RE: 709-FY23-006

I am amending my initial statement on the cause of the accident involving N565TF that occurred on March 19, 2023. I request that this document and Piper Service Letter #1318A be included in all your reports.

SERVICE NO. 1318A LETTER

BRAKE LINE MODIFICATION

Figure 1
Brake Line Location and Routing

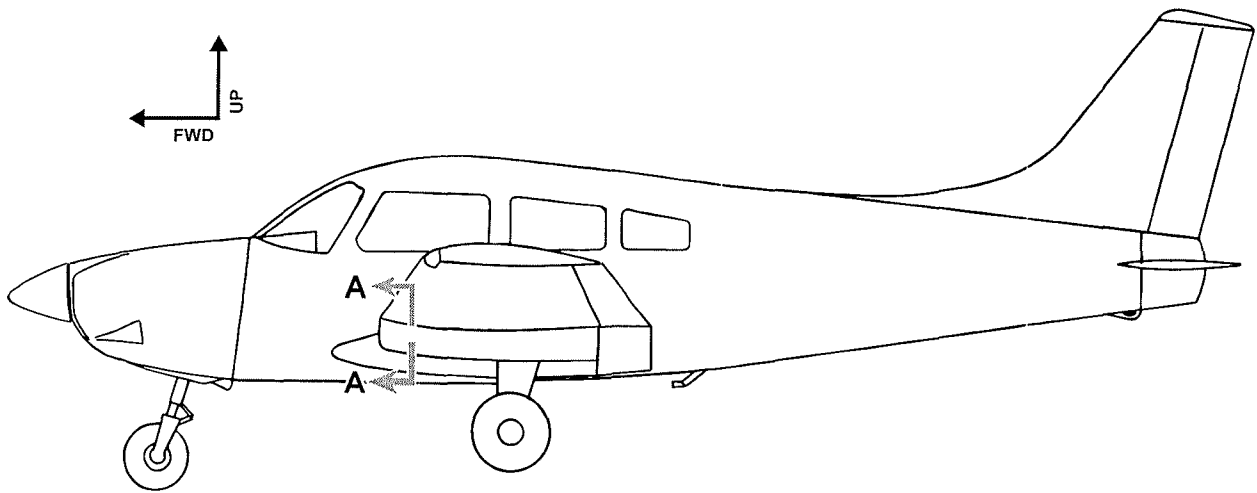
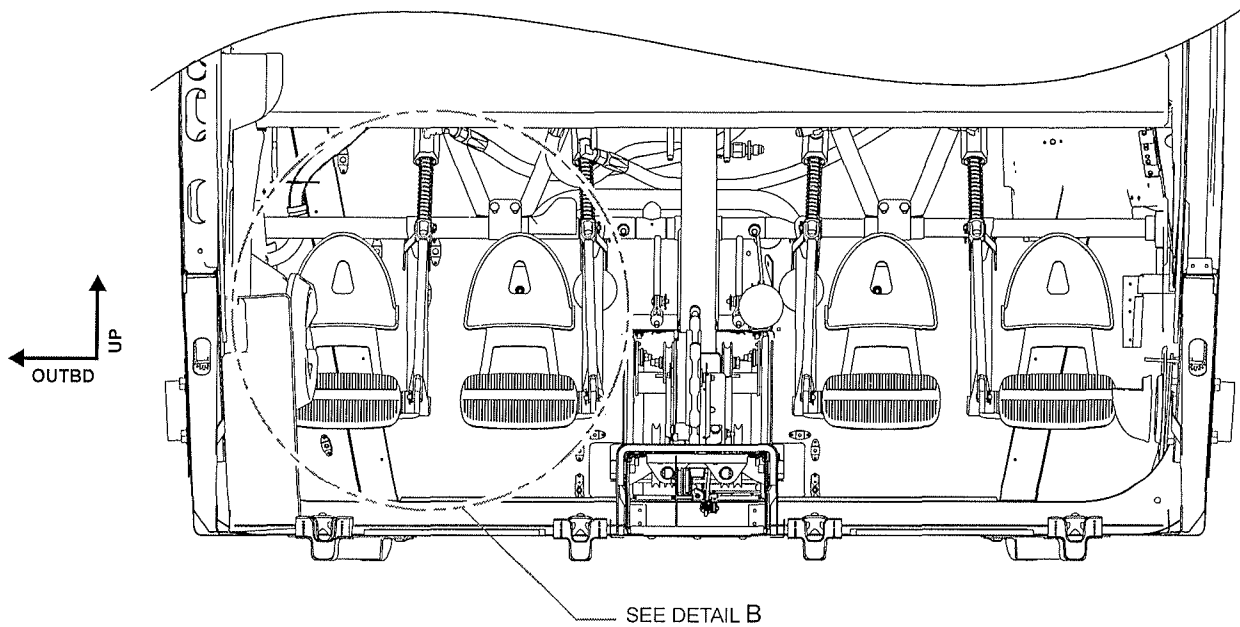
In some of the affected airplanes, the brake line (hose) may have enough freedom to move into a position that obstructs the pilot's left pedal, restricting control of the brakes and rudder. This service letter provides instructions for correction and modification of the brake line routing to prevent pedal obstruction.

1. Locate brake line near the left foot pedal on the pilot's side of the cockpit as shown in Figure 1. Compare the routing of the brake line and correct as required.
2. Secure the brake line to the flange on the firewall stiffener as shown in Figure 2. Slit the firewall blanket as required to install the clamp, screw, washers, and nut, to the 0.191 inch hole in the flange.
